Addendum No. 2

Date: January 26, 2023

Project: Longview District No. 122
VESTIBULE SECURITY PROJECT PHASE II
Project Number 2021-18
Longview, WA

ADD2.17

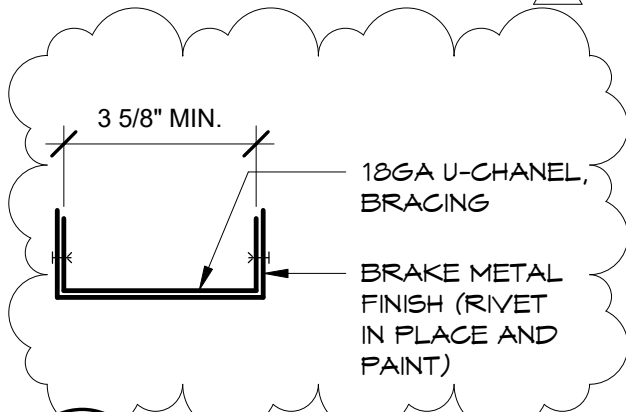
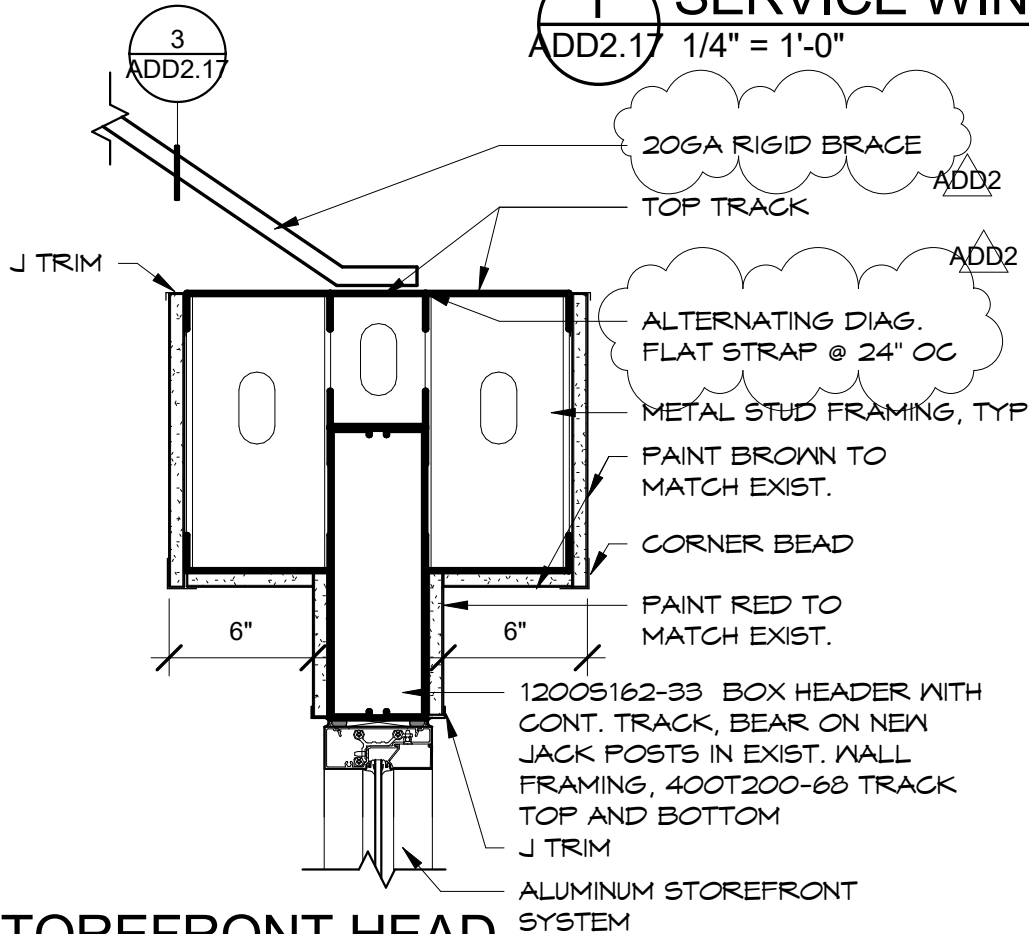
- 2.17 Drawing 2/A6.3
Add See attached detail clarifying diagonal bracing, clouded ADD2.
- 2.18 Drawing 3&5/A7.3
Add Wood backing in metal framing full length of jamb and head.
